# SERVICE BULLETIN

M-916

## 1986 FXRD HEAT SHIELD AND PASSENGER FOOTBOARD MOUNTING STUD

Figure 1. Heat Shield Mounting

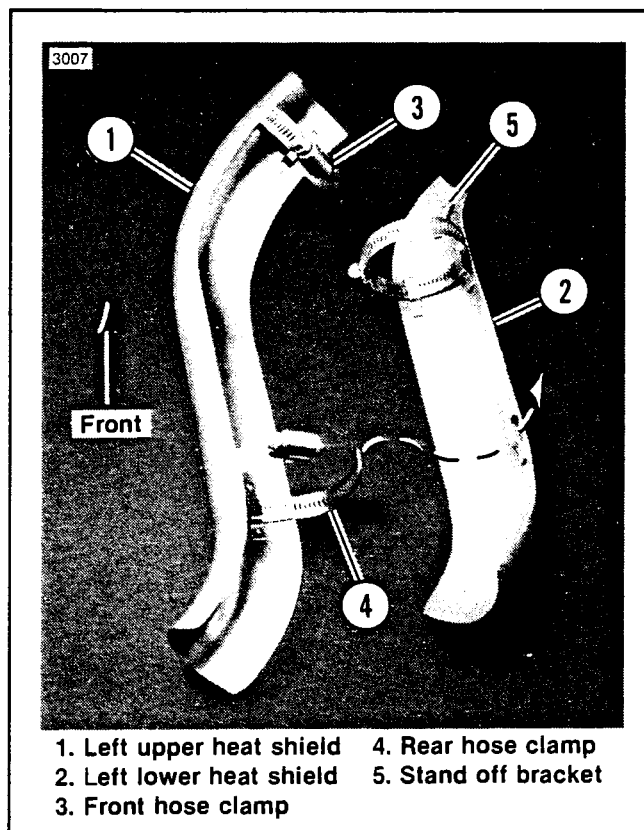
Any 1986 FXRD manufactured with a Vehicle Identification Number of 1HD1EHL18GY122348, or later, have a heat shield installed at the underside of the left exhaust pipe.

FXRD motorcycles with a prior VIN were shipped without this heat shield and it will be necessary to install this shield on those vehicles. The kit, part number 65789-86, consisting of the new lower heat shield and two hose clamps, will be furnished for each subject vehicle sold or at your dealership.

1. Remove the left upper heat shield (1) from exhaust pipe.
2. Remove the rear hose clamp (4) from the shield, just removed, and insert the hose clamp through the bracket from the opposite side so that the worm drive is as shown.
3. Feed the rear hose clamp end, of the left upper shield (1), through the two rear brackets on left lower heat shield (2) so that both shields share a common clamp.

*The upper bracket (5) on the left lower shield is a stand off bracket and is not meant for retaining a hose clamp.*

4. Spread the clamps apart while working them over the exhaust pipe. Position shields with lower heat shield (2) at underside of exhaust pipe and the upper heat shield (1) at top.

5. Tighten clamps gradually while aligning the upper shield with the cross over shield. Position worm drive screws so that they can be tightened thoroughly with a socket driver. Tuck in free end of clamp straps so that they do not protrude.

Figure 2. Passenger Footboard Mounting

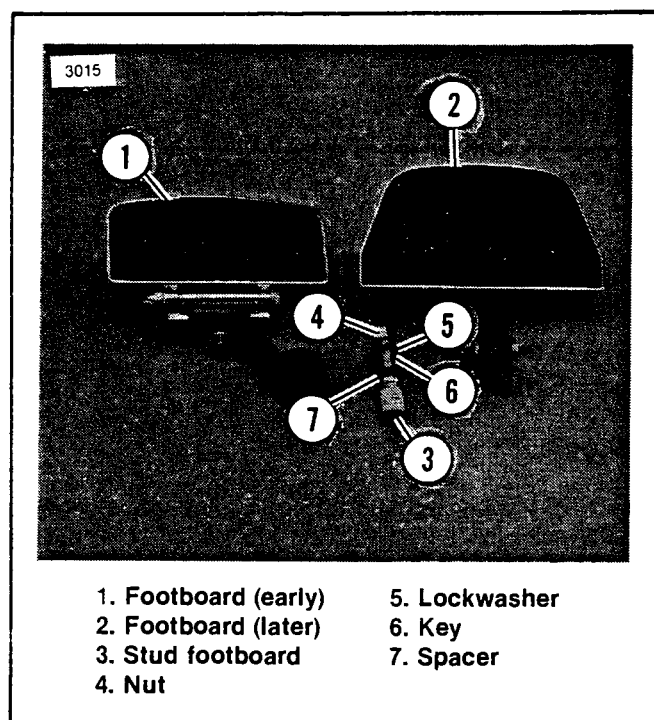
Since its introduction there have been two different style passenger footboards installed on FXRD production vehicles. Footboard (1) was the earlier, of the two footboards, followed by footboard (2). Footboard (2) has a longer mounting stud for increased clearance between the left footboard and the exhaust system. Footboard (1) does not require the longer stud. Some of the FXRD vehicles that require the heat shield installation, were also built and shipped with a left footboard (2) equipped with the shorter stud. The left footboard, on these vehicles, must be removed and the shorter stud replaced with a longer stud. This operation should be performed while installing the heat shield.

1. Remove nut (4).
2. Pull stud (3) outward with exhaust support far enough to allow key (6) to fall free.
3. Once key is free the stud can be pulled through exhaust support bracket and out of frame.
4. Remove footboard (2).

1. Insert replacement stud part no. 50962-86 through exhaust support. Pull exhaust support outward just far enough to install spacer (7) and key (6) be-

tween exhaust support and frame. Use needle nose pliers to insert key in keyway as space is limited.

2. Align key with keyway and insert stud through frame.
3. Place lockwasher (5) over end of stud (3) and thread on nut (4).
4. Tighten nut (4) to a torque of 78 ft-lbs.
5. Install footboard (2).
